Delegated officer report for planning application

Application no. CDN/25/0104

Proposal: Discharge of conditions 3 (specification), 4 (equipment colour), 5 (CCTV), 7 (landscaping), 8 (trees), 12(Wildlife habitats), 13 (habitats) and 14 (hedgehogs) attached to planning permission referenced 135354/VO/2022.

Address: Clayton Old Hall, Ashton New Road, Manchester, M11 4RU

DETAIL 3
NORTH BOUNDARY FENCE AT SCREW PILE LOCATION

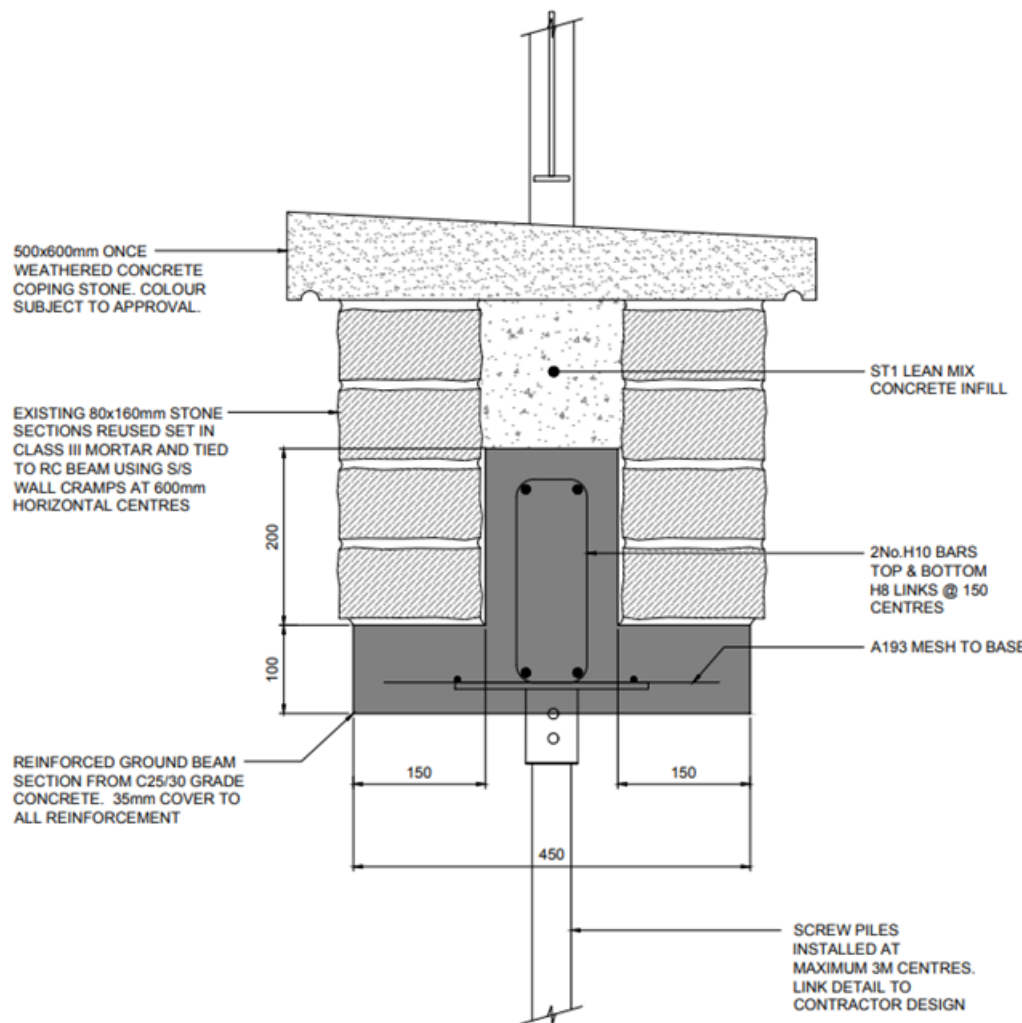
The section drawing shows a concrete coping. Are existing copings in concrete? Other wise we should be asking for natural stone.
